Access Compliance Report

Public Rights-of-Way

Intersection ID: 47363	Main Street: JORDAN_PL	Cross Street: MATHESON_AV	Location: SE
ADA ID: CC11862A9DD5	Ramp Type: Combination1	Initial Pass/Fail: Fail	Overall Compliance: No
		Severity Score: 10

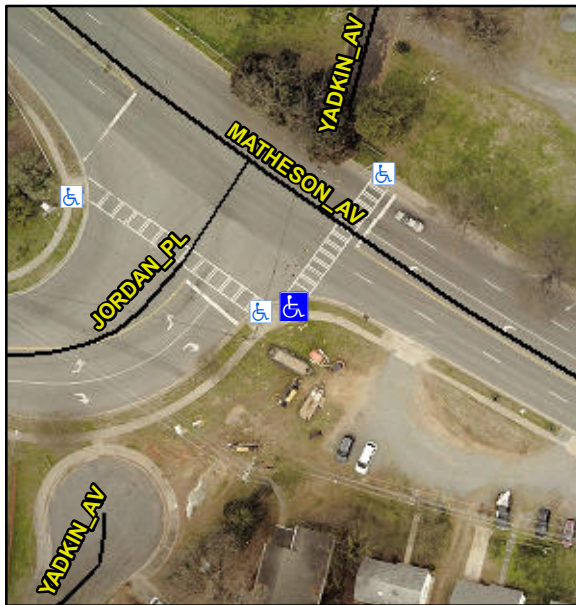
LT RP < 5%

Not Found, R304.5.1, R304.5.3

Remove & Replace Entire Ramp.
